COLORADO DIVISION OF RECLAMATION, MINING AND SAFETY
MINERALS PROGRAM INSPECTION REPORT
PHONE: (303) 866-3567

MINE NAME: Clayton Sand and Gravel	MINE/PROSPECTING ID#: M-1999-022	MINERAL: Sand and gravel	COUNTY: Saguache
INSPECTION TYPE: Monitoring	INSPECTOR(S): Bob Oswald	INSP. DATE: July 5, 2013	INSP. TIME: 11:30
OPERATOR: Eddie Clayton	OPERATOR REPRESENTATIVE: None	TYPE OF OPERATION: 110c - Construction Limited Impact

PHOTOGRAPHS

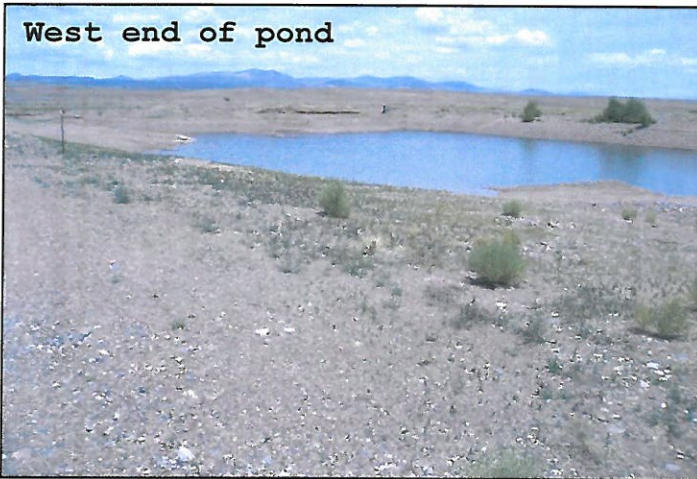
There was no fuel or oil stored on the site. The operator is limiting the amount of debris and contaminants on the site. There was a small accumulation of debris items, including empty oil/hydraulic fluid buckets, above the south slope of the pit (near the elm tree). Please be reminded that the approved plan does not include fuel or oil storage onsite, and that contaminants should be disposed of promptly. Empty oil containers should be removed, before they leak on the soil.
